Item 3.**Development Application: 341 Liverpool Street, Darlinghurst - D/2021/1060****File No.: D/2021/1060****Summary**

Date of Submission:	16 September 2021
Applicant:	Brendan Moon
Architect/Designer:	BEEM Projects
Owner:	Mr Adrian Michael Palmer and Ms Chloe Patricia Renee Robson
Planning Consultant:	BEEM Projects
Heritage Consultant:	Zoltan Kovacs Architect
Cost of Works:	\$664,400
Zoning:	The site is located in the R1 General Residential zone. The proposed development is for alterations and additions to a dwelling which is permissible with consent in the zone.
Proposal Summary:	<p>Alterations and additions to an existing heritage item terrace house, comprising; a ground floor side extension, internal alterations, and construction of a laneway garage/studio addition with car stacker.</p> <p>The application is reported to the Local Planning Panel as it represents contentious development, with 25 or more unique submissions by way of objection.</p>
Summary Recommendation:	The development application is recommended for approval, subject to conditions.

Figure 13: Proposed Garage Car Stacker Pit Excavation

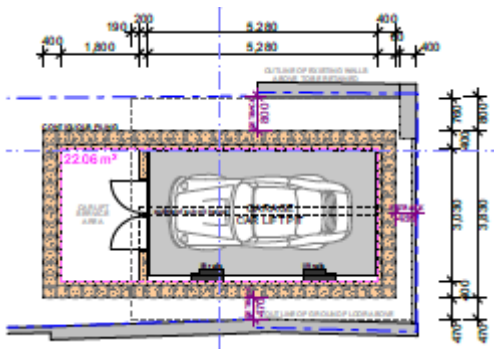
- (l) **Issue:** Objection related to car stacker noise and vibrations impacting upon adjacent residential dwellings when in operation.

- (u) **Issue:** The proposed excavation for the car stacker will require an existing sewer line to be diverted. The applicant should provide a detailed sewer diversion designed by a duly qualified professional and approved by Sydney Water prior to any Council DA consent.

A condition is recommended requiring the submission of a mechanical parking report to be prepared and approved by the appointed certifier prior to CC. The report is to address the predicted noise and vibration levels arising from the car parking area received by nearby receivers, including references to relevant Standards.

Response: The applicant has submitted a services diagram which illustrates diversion of the existing to facilitate the proposed extent of excavation.

Figure 14: Proposed South (Mont Clair Lane) Elevation

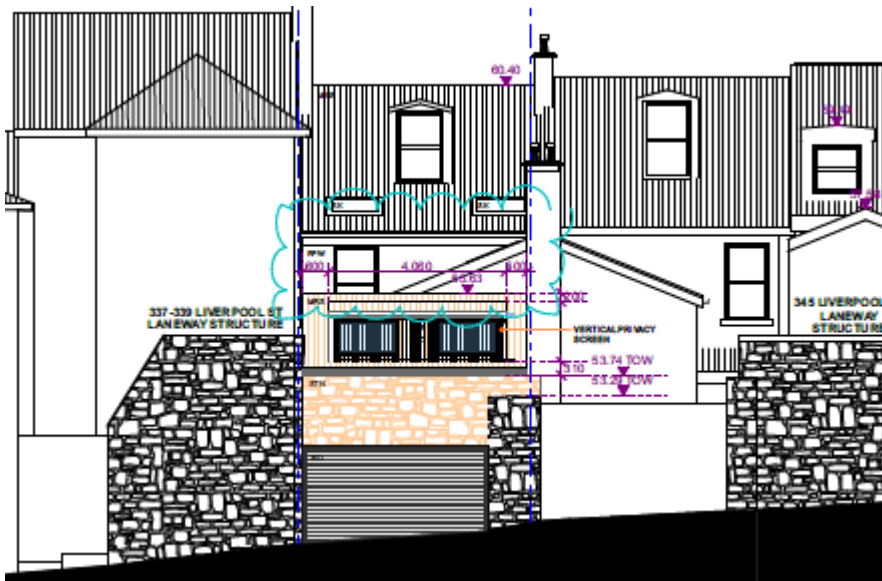
- (e) **Issue:** The proposed laneway addition is excessively high and inconsistent with the development pattern in the rear lane. The proposed addition will constrain amenity and outlook of surrounding properties.

- (f) **Issue:** The proposed laneway addition appears to exceed the 5.4m height limit applying to laneway development under Section 4.1.6.1 of the Sydney DCP based upon comparative RLs.

Response: The design and form of the proposed laneway addition has undergone several revisions over the course of the assessment period, further details of which are discussed under 'Amendments' section of this report.

The revised form is consistent with the Sydney DCP's design criteria for laneway development and maintains a reasonable level of level of amenity to the principal dwelling, the site and surrounding properties, as required by Section 4.1.6 of the Sydney DCP.

Response: The submitted architectural drawings indicate that the proposed laneway addition will have a maximum height of RL55.63 to the top of the roof ridge. Spot levels on the submitted survey plan indicate the existing ground level in the approximate location underneath the proposed roof ridge to be RL50.30.

Accordingly, the proposed laneway addition is less than 5.4m in height and complies with the laneway development controls outlined under Section 4.1.6.1 of the Sydney DCP.

Figure 15: Proposed South (Rear Facade) Elevation

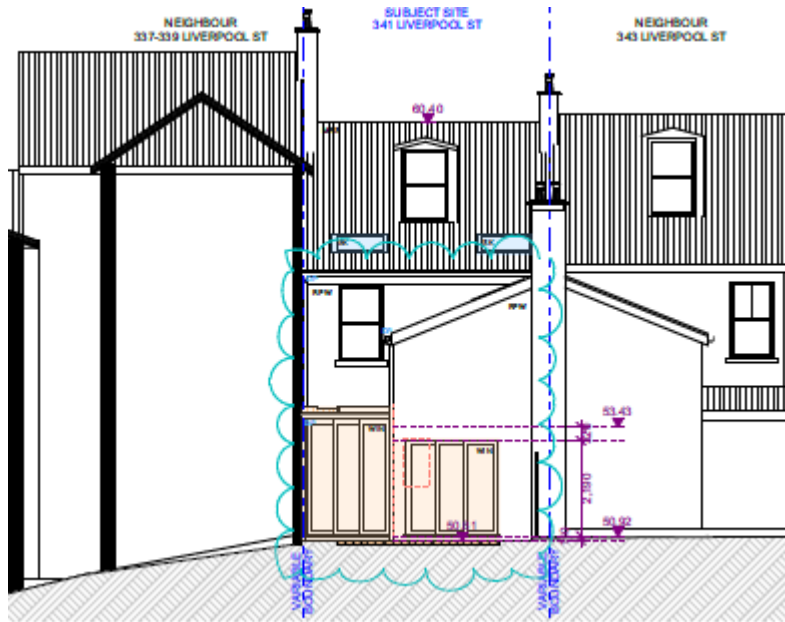
5. A design modification condition is recommended requiring the 2x proposed skylight windows to the rear principal roof to be changed to vertically proportioned windows to be positioned parallel to the slope of the roof, rather than horizontally positioned as proposed – details are to be submitted and approved by Council prior to construction certificate (CC).
